Errata OVI40 UI V1.8 Batch 1 Kit

In Kit Bag 1

Möglicher Kurzschluß (photo DF9EH)

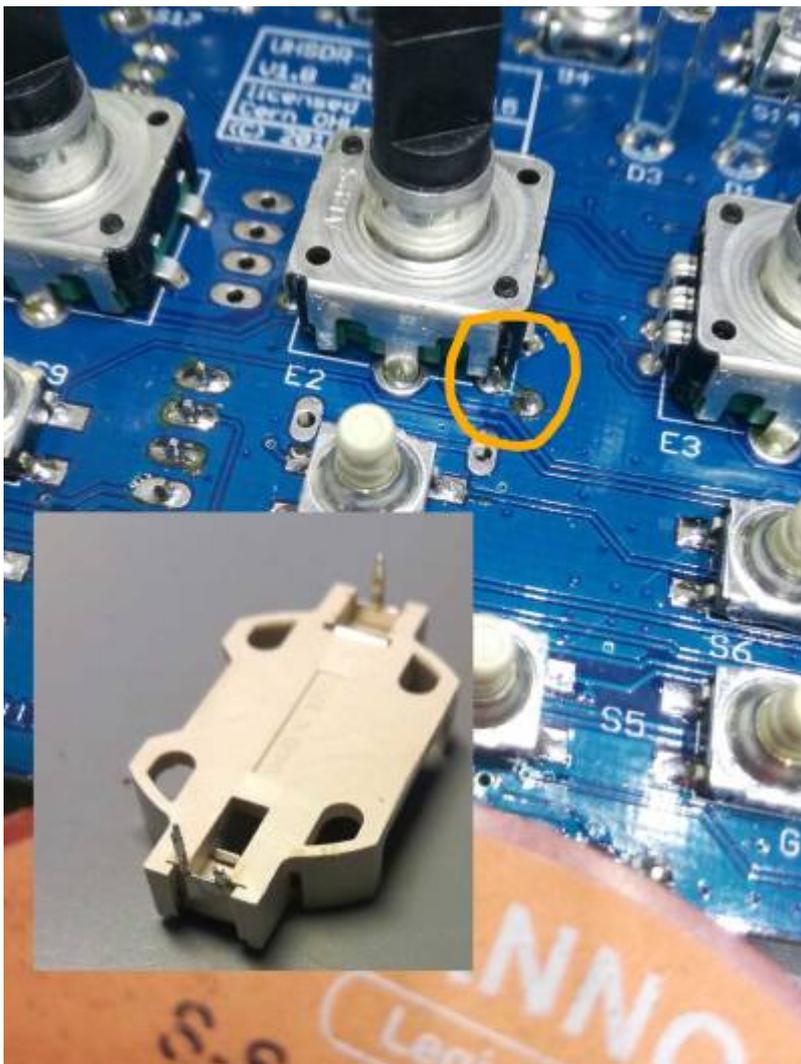
- Mini-USB socket J11 is "Type A" - this is wrong. "Type B" is mandatory to be used. Please get the correct part, e.g. Buerklin.de order number 72F2280
- The CR2032 back-up battery holder needs to be modified before soldering it in. On pin needs to be shortened so it is flush with the PCB surface TOP layer, see photo
